Certificate of Appropriateness
112 S. Hancock Street

April 3, 2023

Proposed Work

Proposed Site Plan

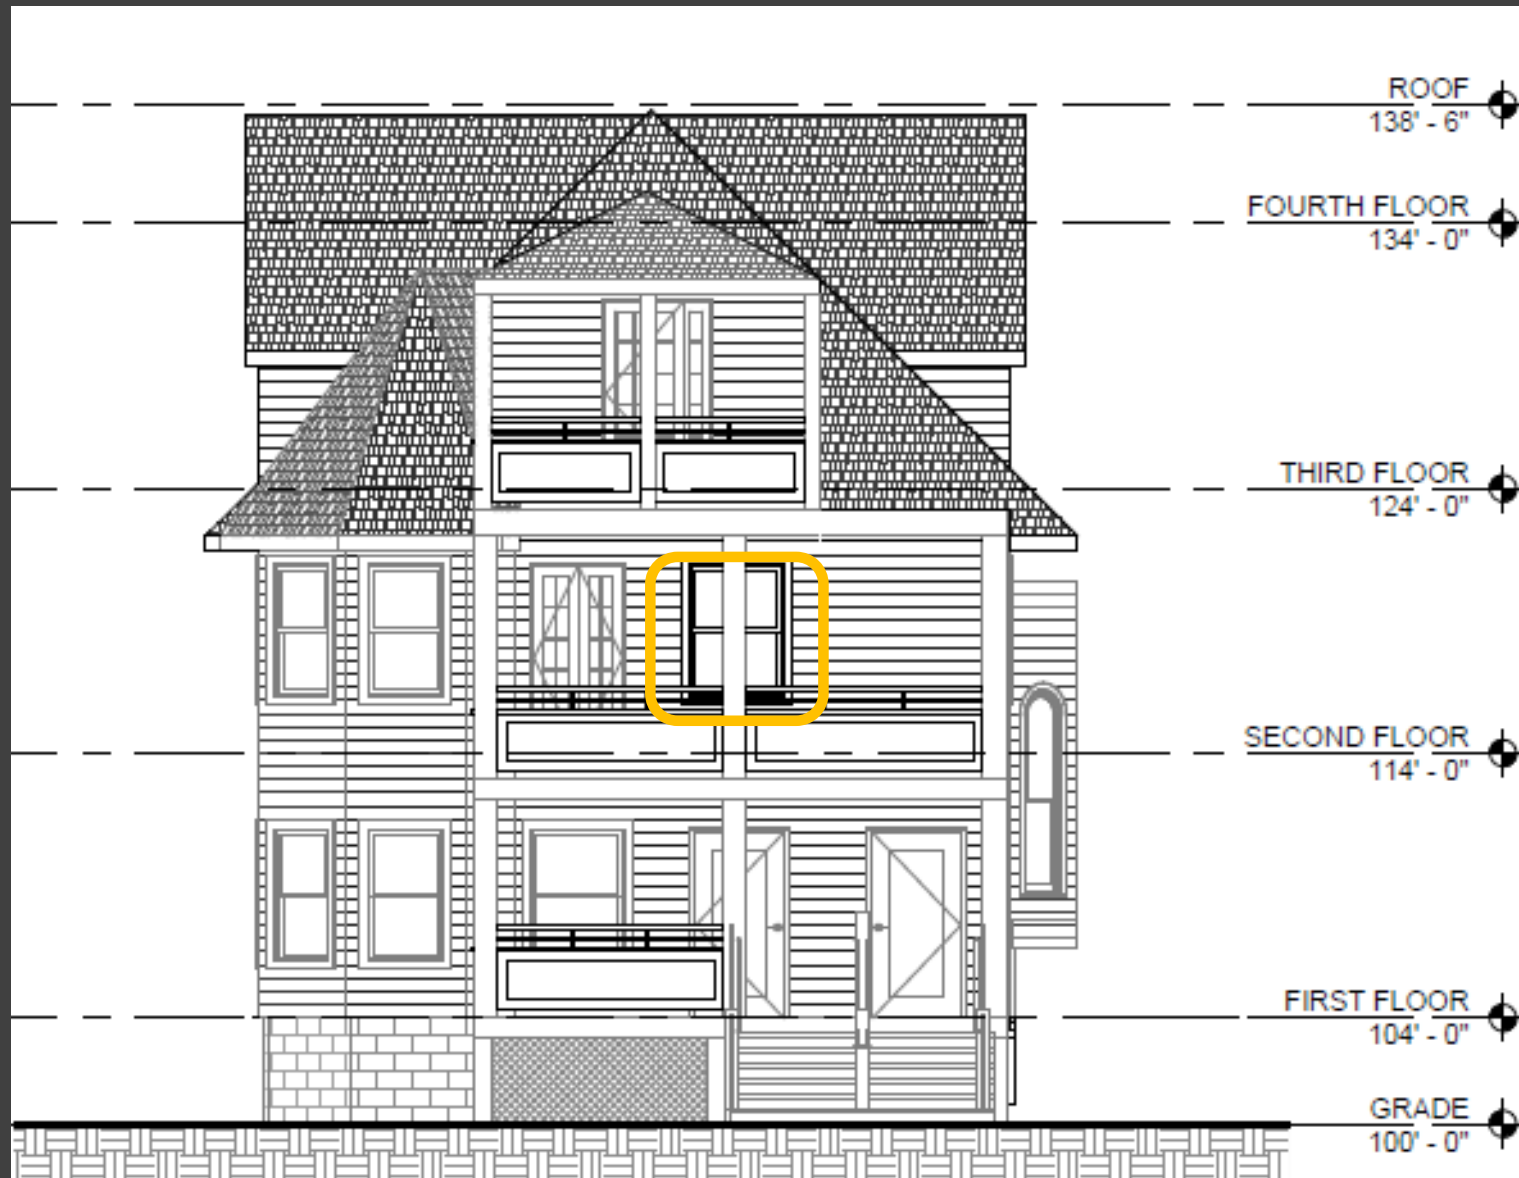
- Construction of new dormer additions
- Addition to rear
- Removal of vinyl siding

Proposed West Elevation

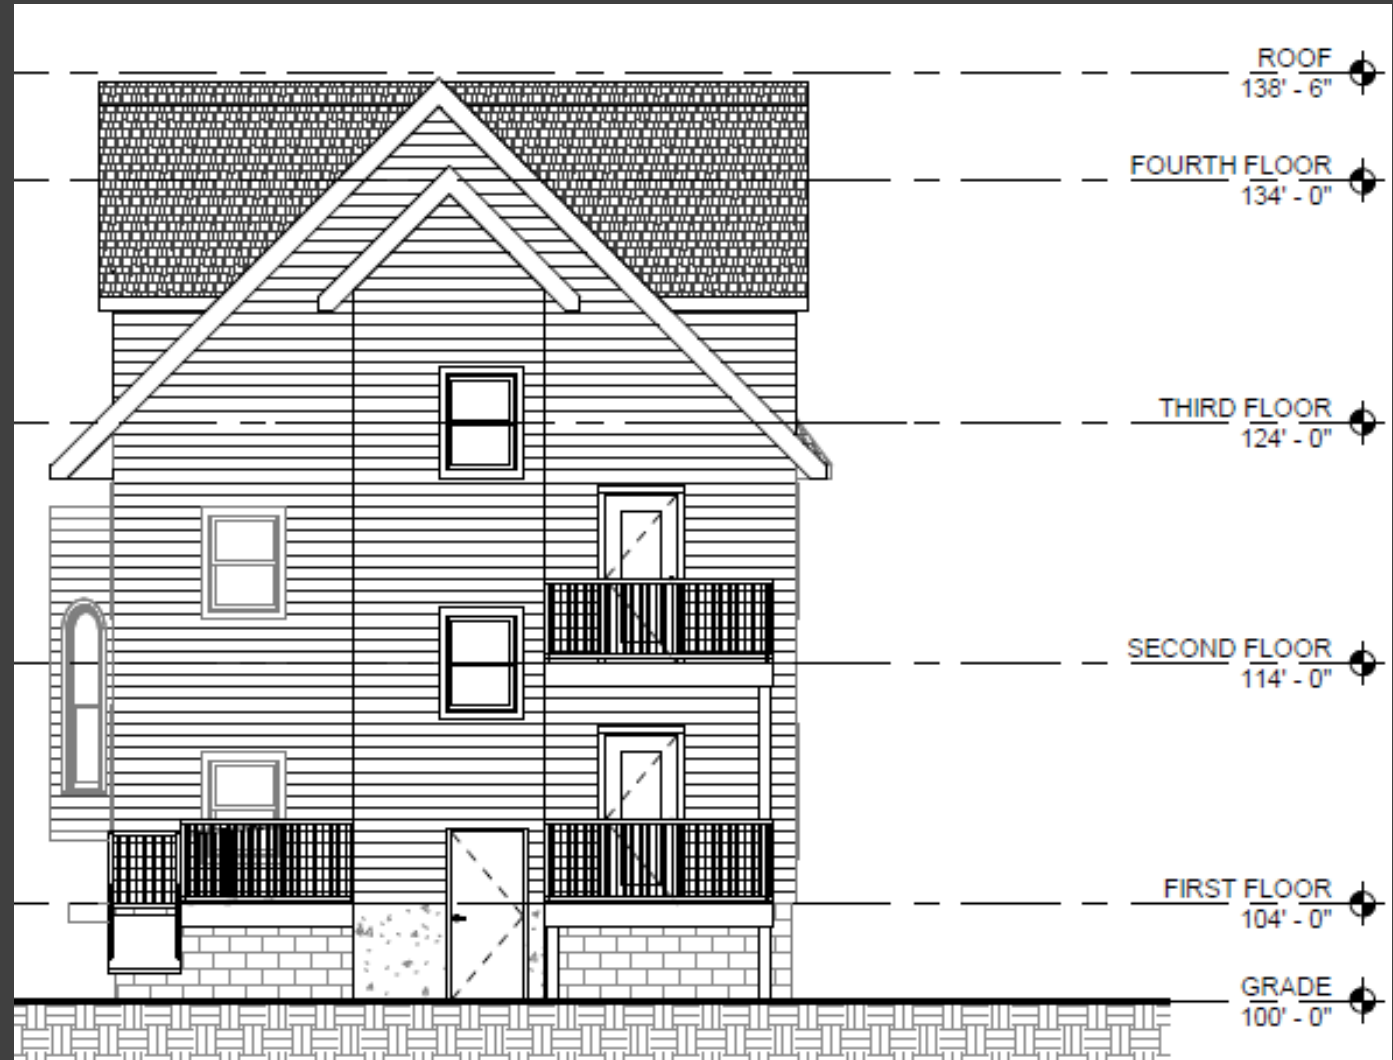
1. Submit updated plans that remove the shed-roof dormers from the design.
2. Final siding and trim specifications be approved administratively by staff. Siding and trim will need to replicate the appearance of the historic wood siding, not the current nonhistoric vinyl siding.
3. Final window specifications be approved by staff. All components will replicate the appearance of wood windows, with no wrapping of the of the window opening.
4. Final door, railing, porch, deck, and roofing materials specifications be approved administratively by staff.
5. Any exterior lighting or mechanicals proposed as part of this project scope will need a Certificate of Appropriateness.
